STANDARD DEPARTURE CHART - INSTRUMENT

RJNH / HAMAMATSU

SAGRA FIVE DEPARTURE

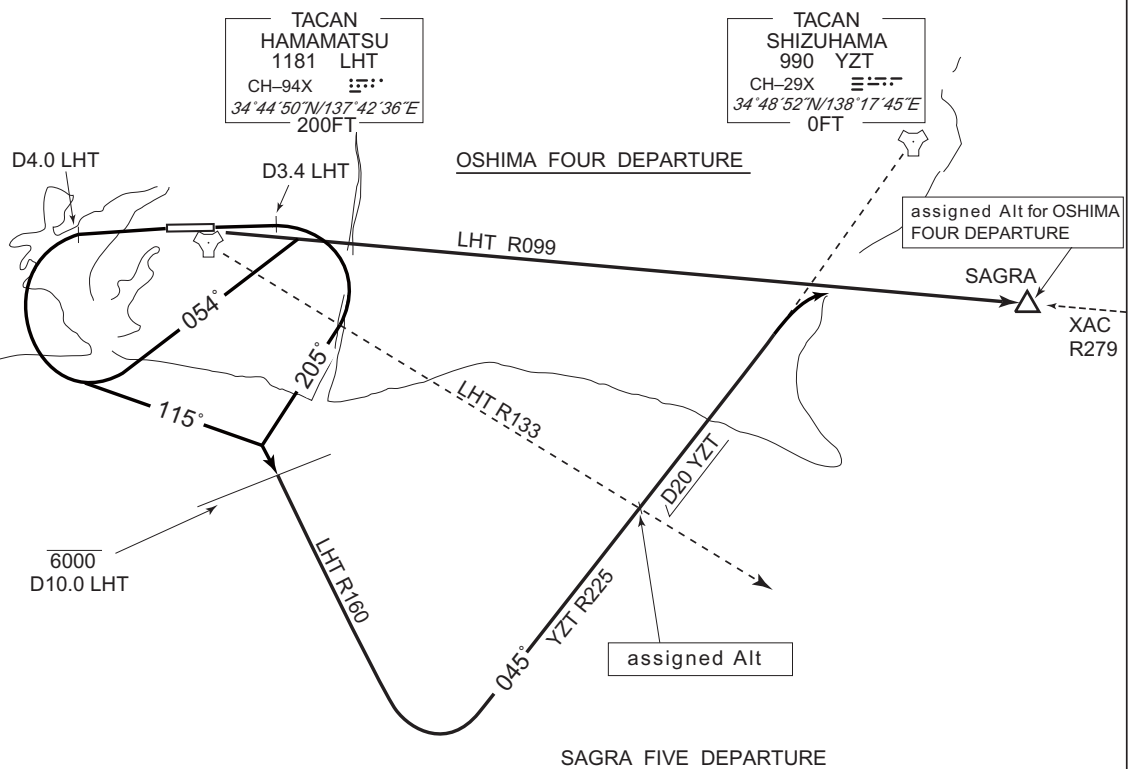
CHANGE : PROC name, PROC course(SAGRA FIVE DEPARTURE, OSHIMA FOUR DEPARTURE). Note deleted(SAGRA FIVE DEPARTURE, OSHIMA FOUR DEPARTURE).

ATSUMI FIVE DEPARTURE

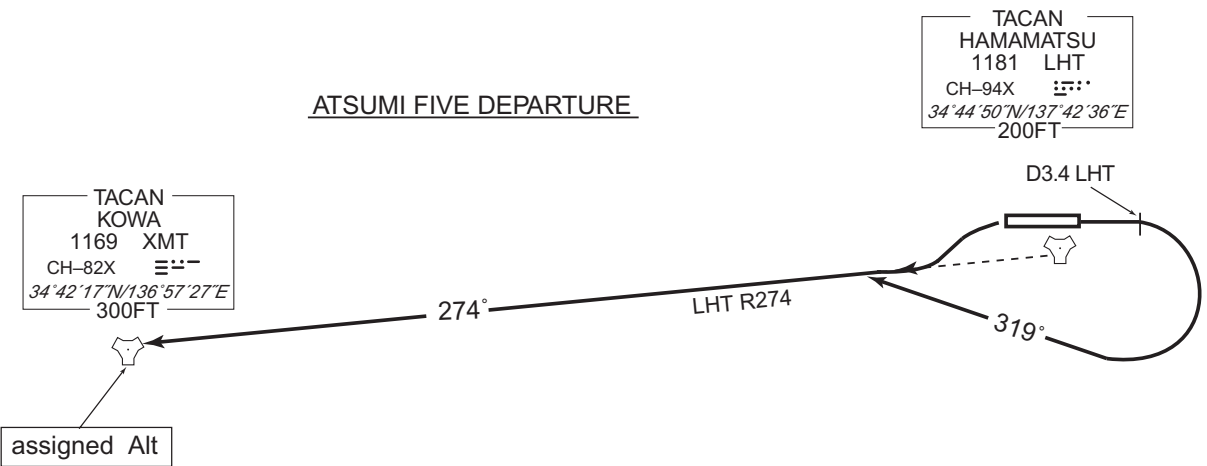
CHANGE : PROC renamed. PROC course. Note deleted.

HAMAMATSU REVERSAL THREE DEPARTURE

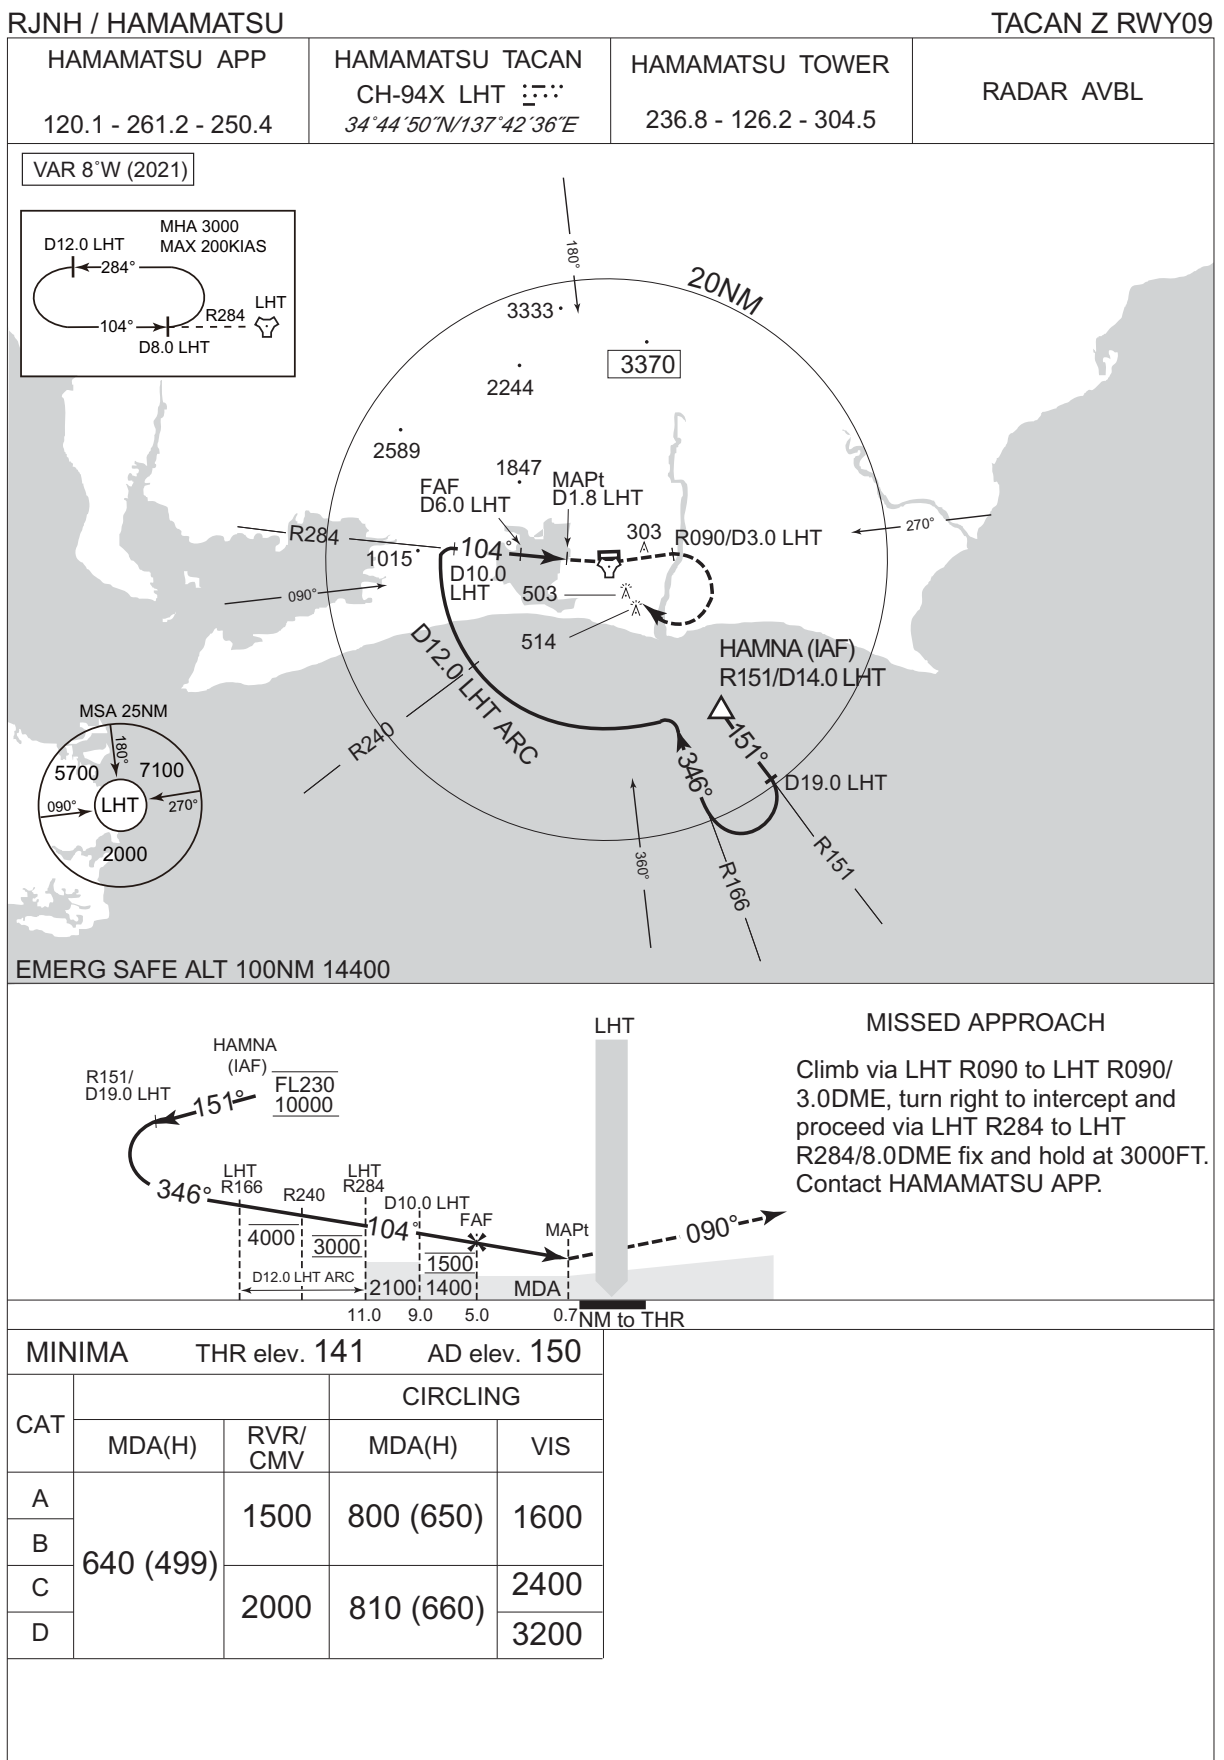
CHANGE : PROC renamed. PROC course. Note deleted.

TACAN Y RWY09

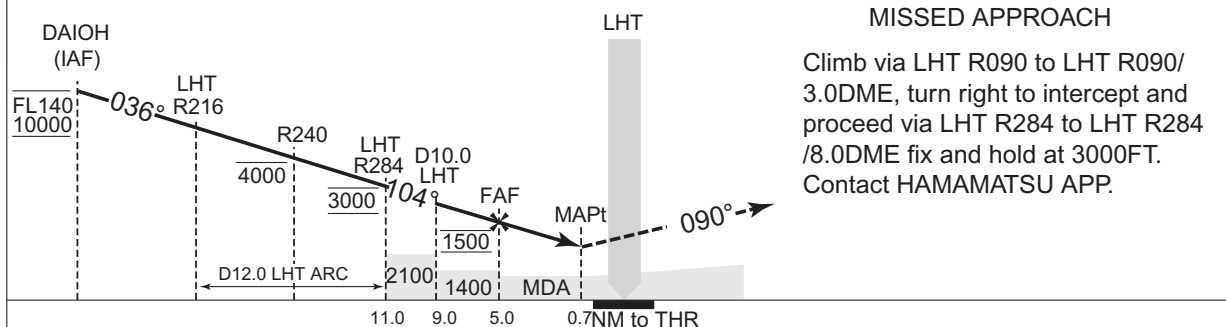
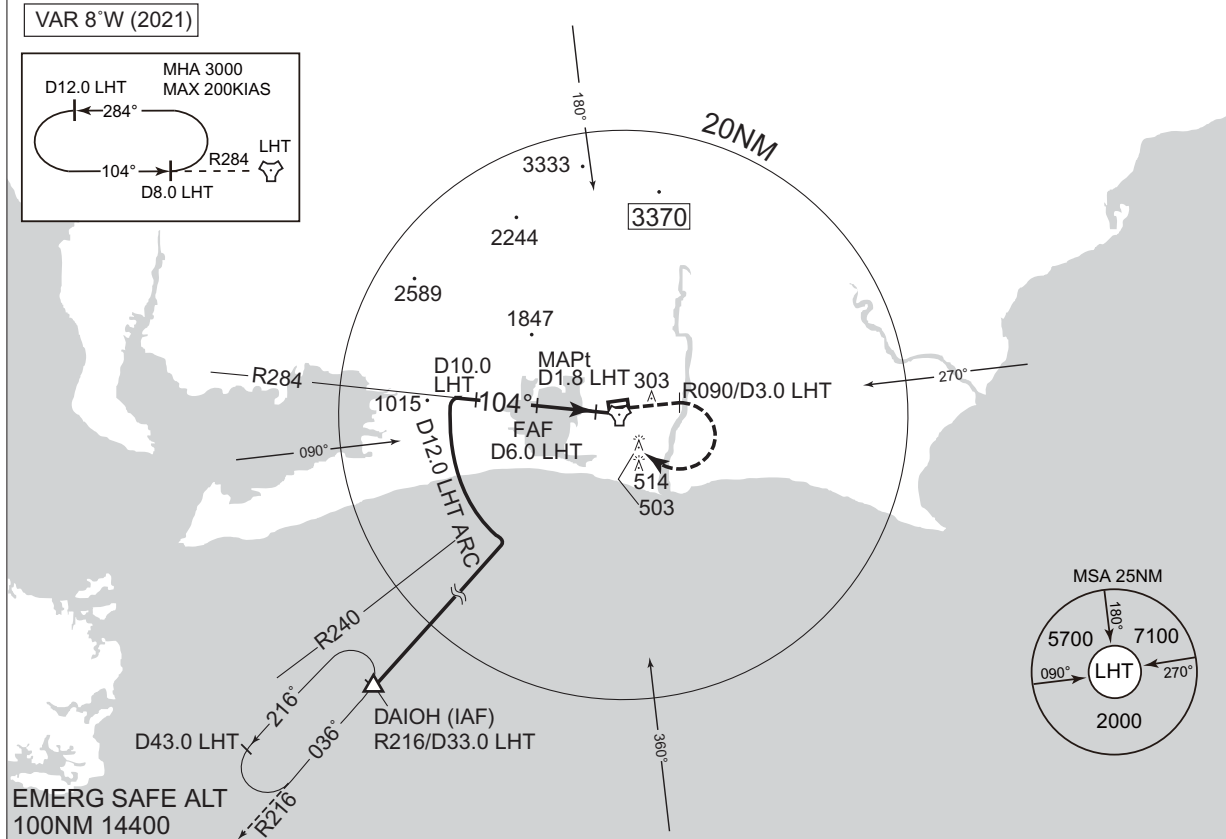
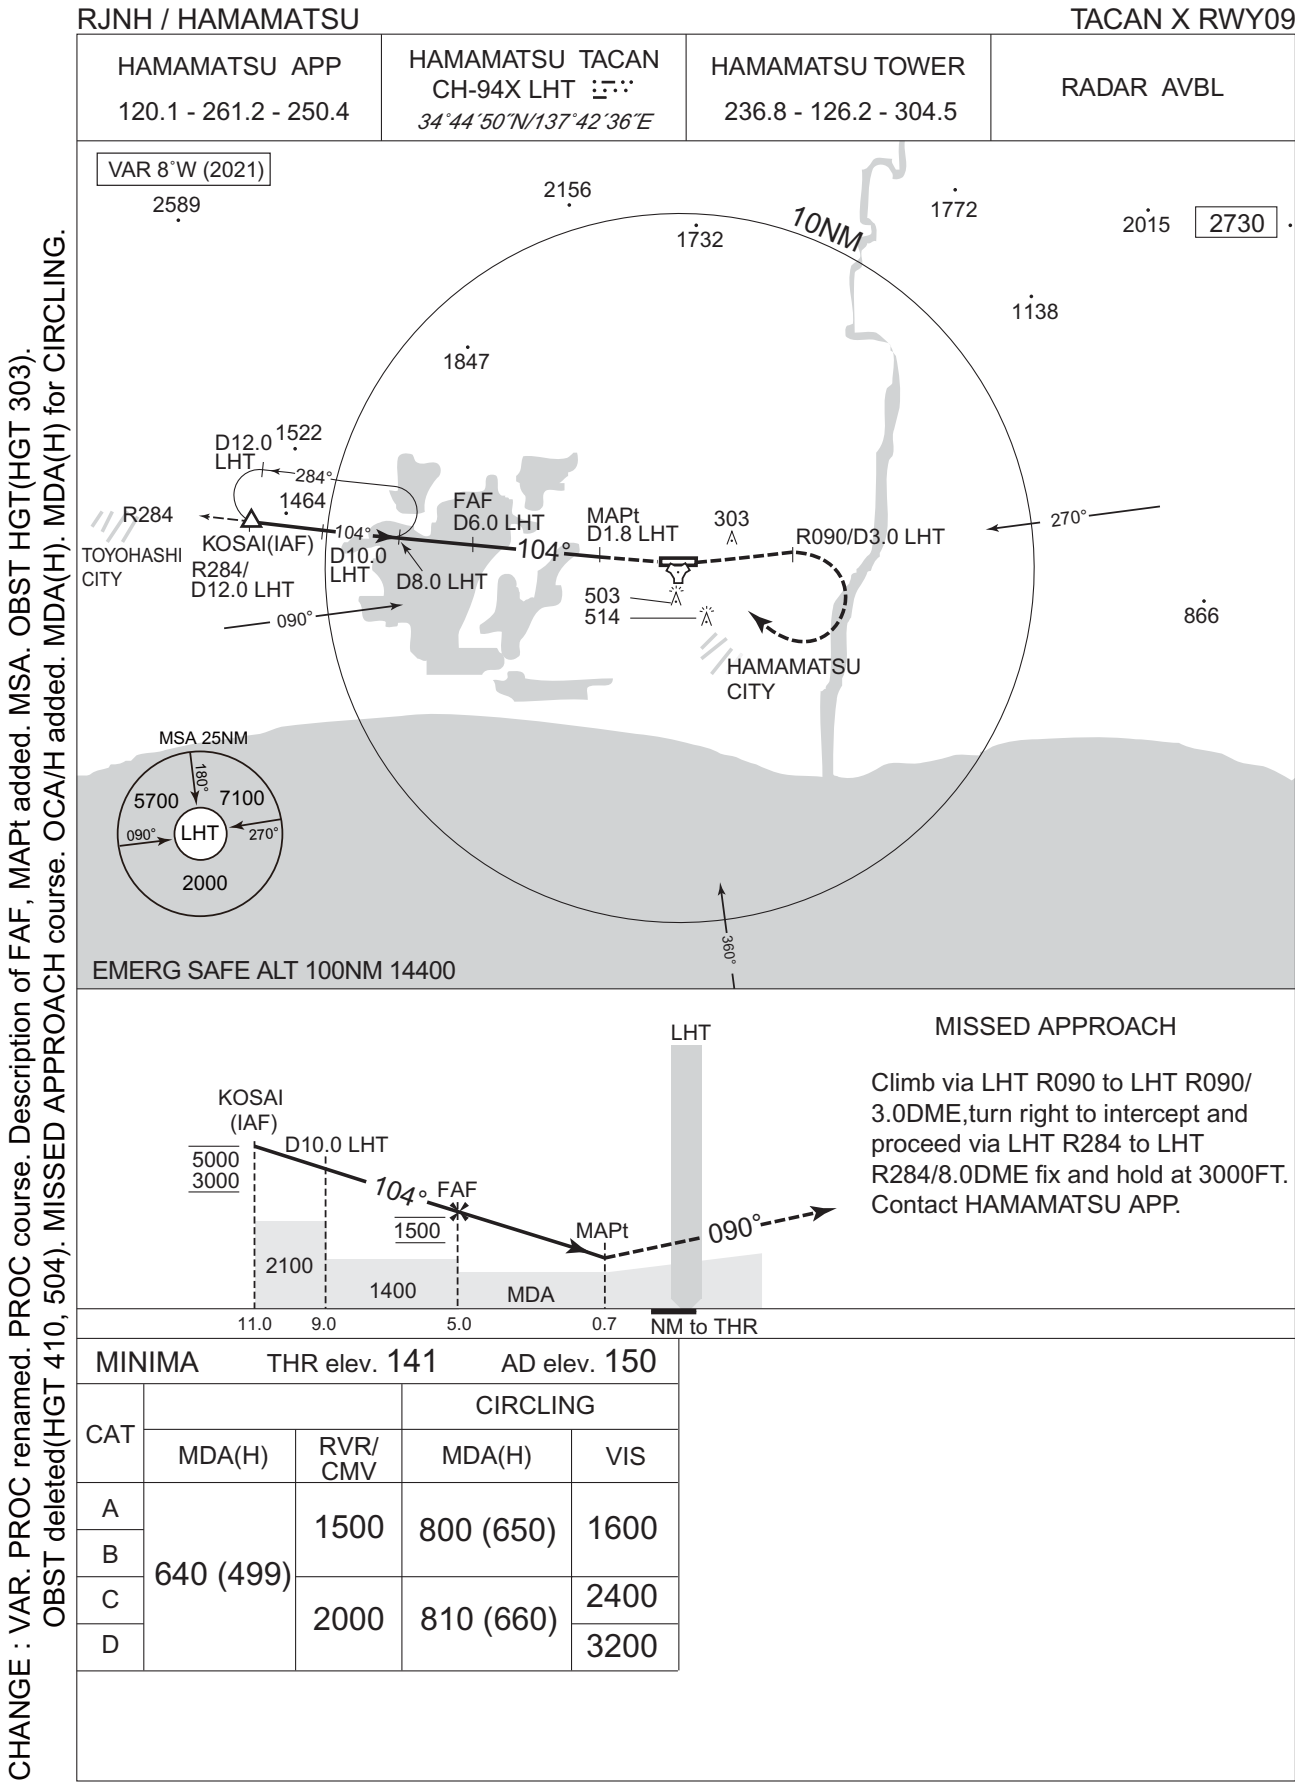
CHANGE : VAR. PROC renamed. PROC course. Description of FAF, MAPt added. MSA. HLDG pattern added. OBST added(HGT 303).
OBST deleted(HGT 410, 504). MISSED APPROACH course. OCA/H added. MDA(H). MDA(H) for CIRCLING.

TACAN Z RWY27

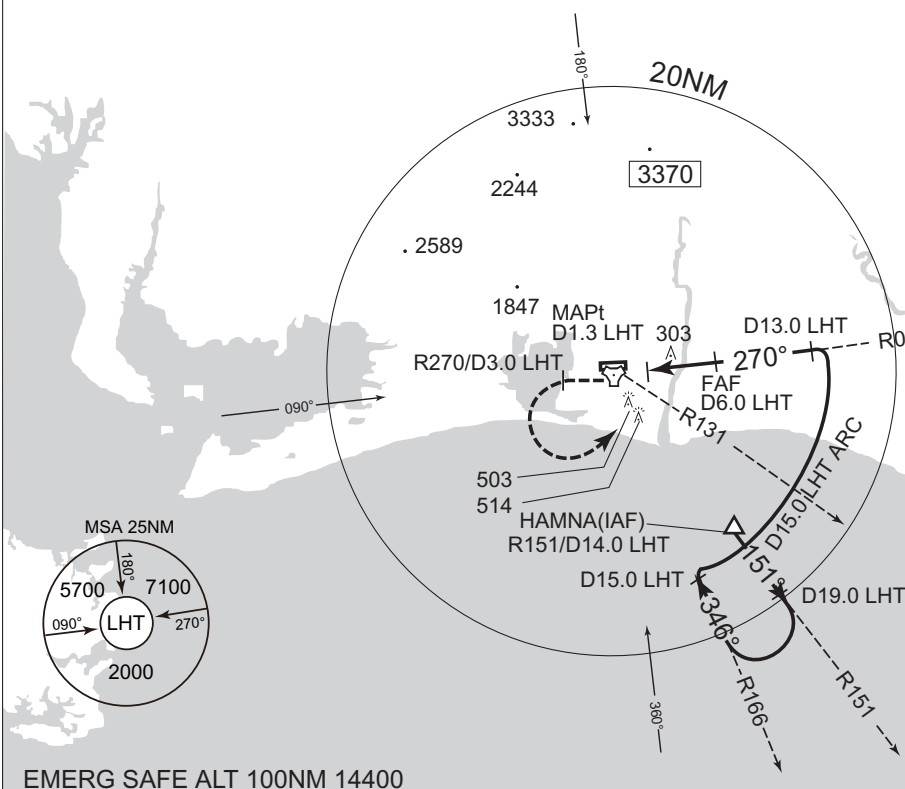
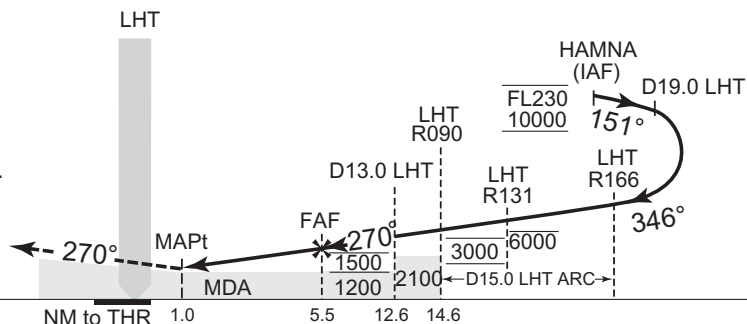
CHANGE : VAR. PROC renamed. PROC course. Description of FAF, MAPt added. OBST added(HGT 303).
OBST deleted(HGT 410, 504). MISSED APPROACH course. ALT restriction(LHT R090). OCA/H added. MDA(H). MDA(H) for CIRCLING.

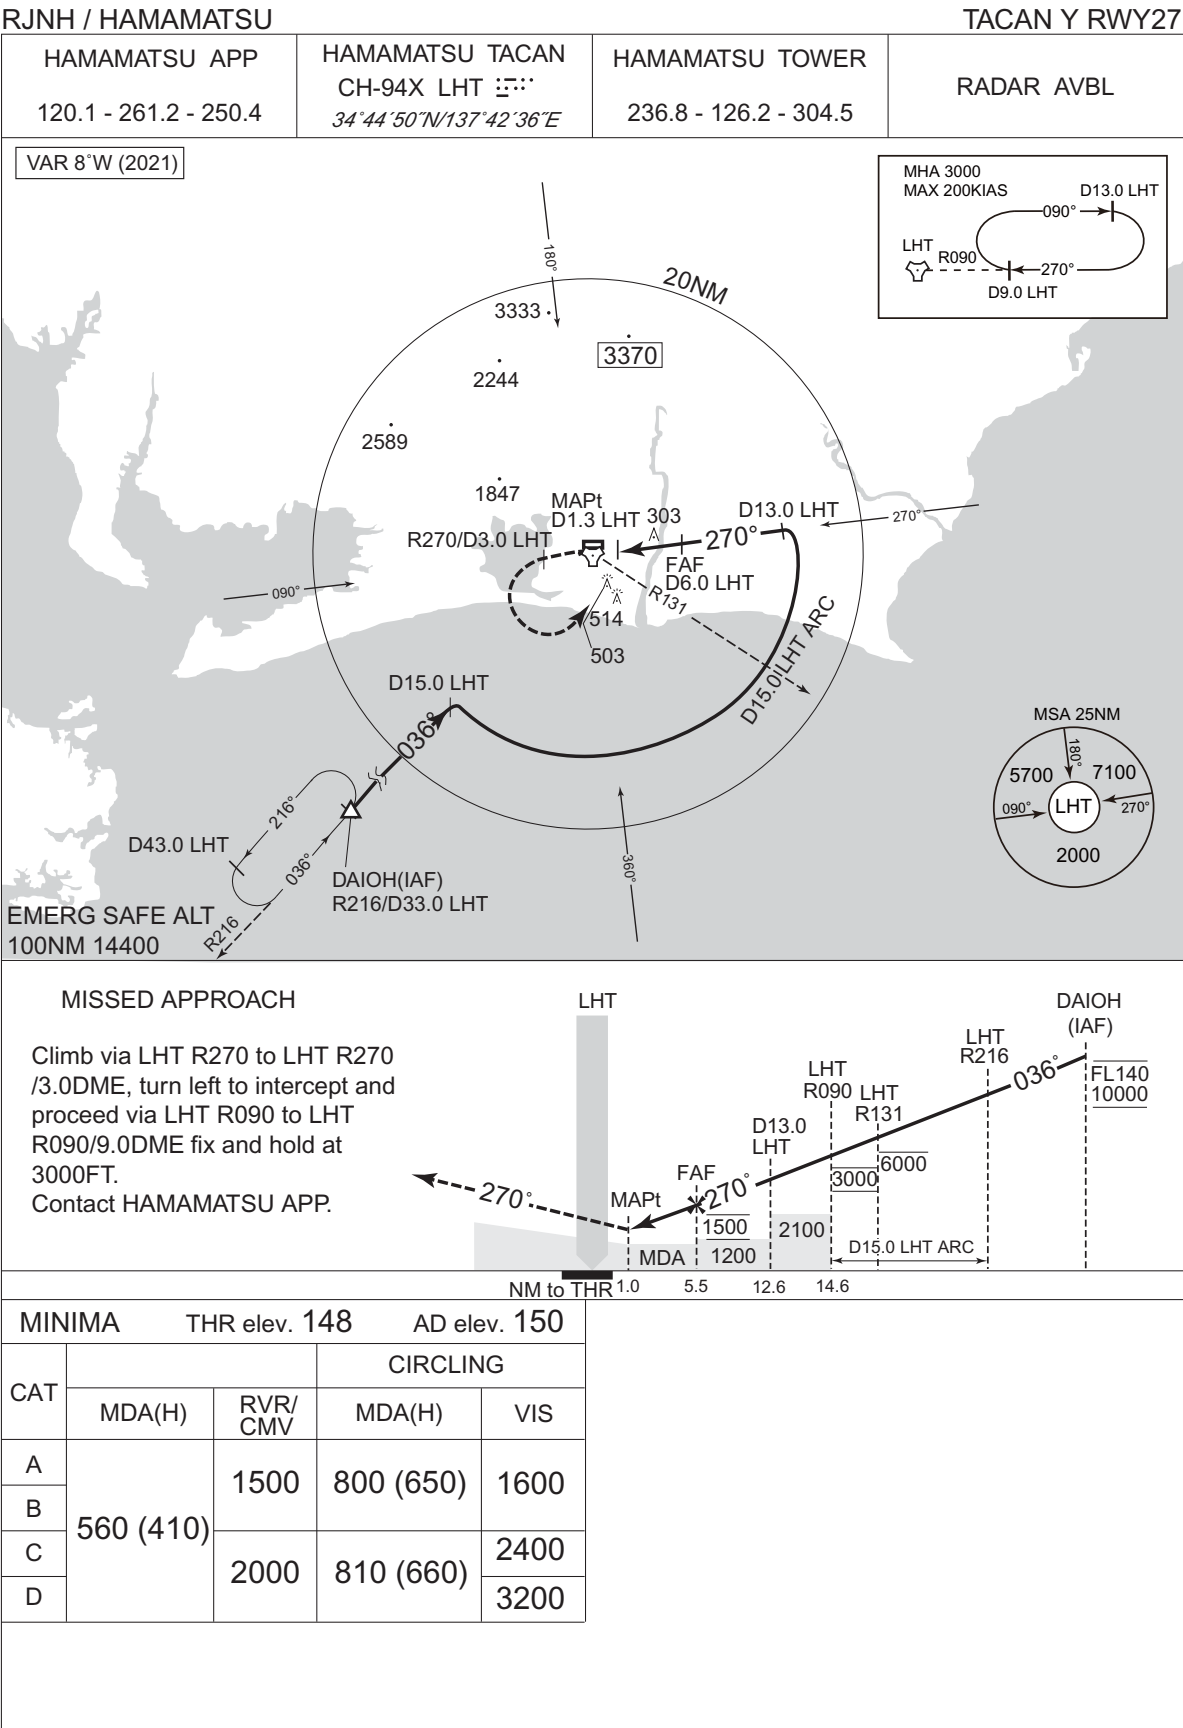
CHANGE : VAR. PROC renamed. PROC course. Description of FAF, MAPt added. MSA. HLDG pattern added. OBST added(HGT 303). OBST deleted(HGT 410, 504). MISSED APPROACH course. ALT restriction(DAIOH, LHT R090). OCA/H added. MDA(H). MDA(H) for CIRCLING.
